**RE: Juan Tabo Hills Estates
Revised Grading Plan
Engineer's Stamp Date: 9/7/18
Hydrology File- M21D018; DRB# 1005278**

**Re: Juan Tabo Hills Estates
Revised Grading Plan
Hydrology File-M21D018; DRB 1005278**

RE: **Juan Tabo Hills Estates**
Revised Grading Plan
Engineer's Stamp Date: 8/30/18
Hydrology File- M21D018; DRB# 1005278

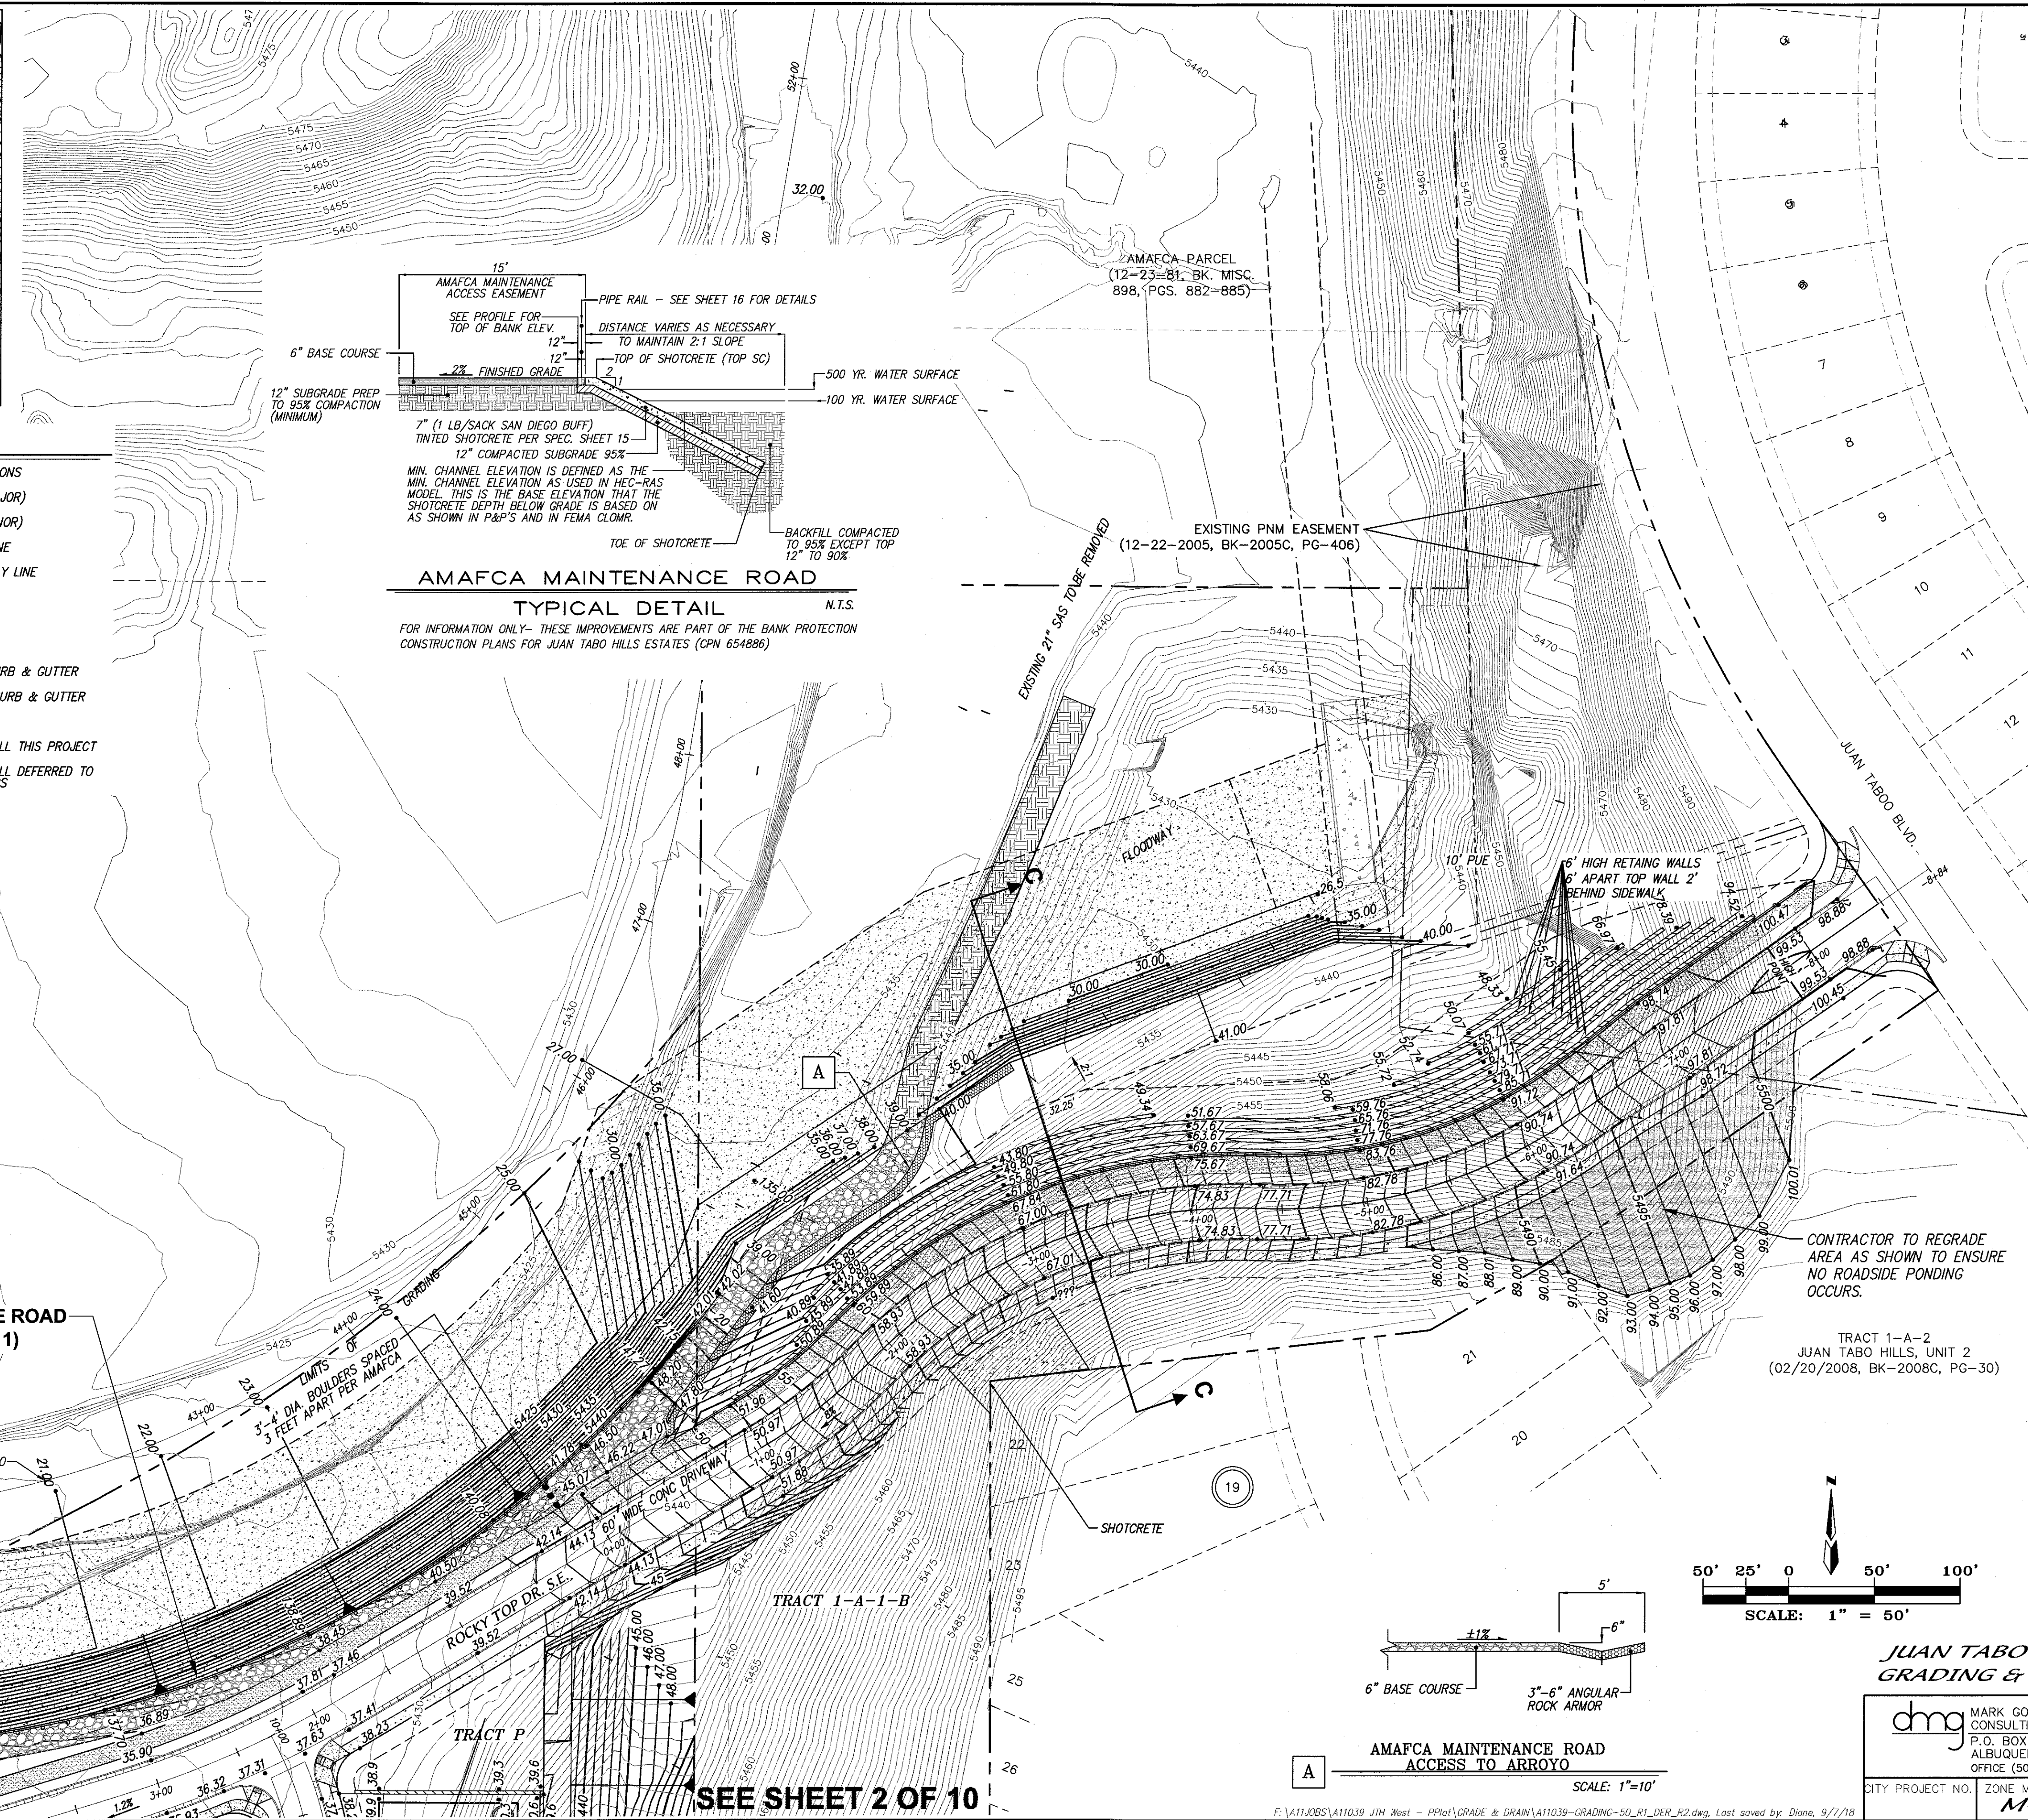
1. Provide self-ponding areas in the interspace (park) between the AMAFCA access road and the public road, or drain away from bank protection per AMAFCA direction. The contours and spot elevations should reflect the access road as sloping at 2% away from the top of shotcrete and back into the park area. If used, the ponding areas should be sized for the 10-day, 100-yr volume with supporting calculations provided. If this grading will be part of the landscaping plan, then the landscaping plan need to be included when resubmitting.
2. Provide rip-rap armoring at the outside bend of Sandia Sunset. If water surcharges out of the NMDOT inlet upstream near MH-47, flows will travel overland down Sandia Sunset and will likely jump the curb at this bend. Mark hand drew a detail and location of this on the previous submittal (sheet 5), but it did not get carried over this time:

1. A typical bank protection/ AMAFCA maintenance road detail showing a 2% cross slope has been added to the grading plan. Since there is no impervious areas in the park areas, the 100 year 10 day storm is equal to the 100 year 6 hour storm event. The required volume and provided volume and depression pond design details has been added to the grading plan. The AHYMO summary printout is attached. Land treatment value of C (100%) was assumed for each of the areas.
2. The armoring detail has been added to the plan and the limits defined.
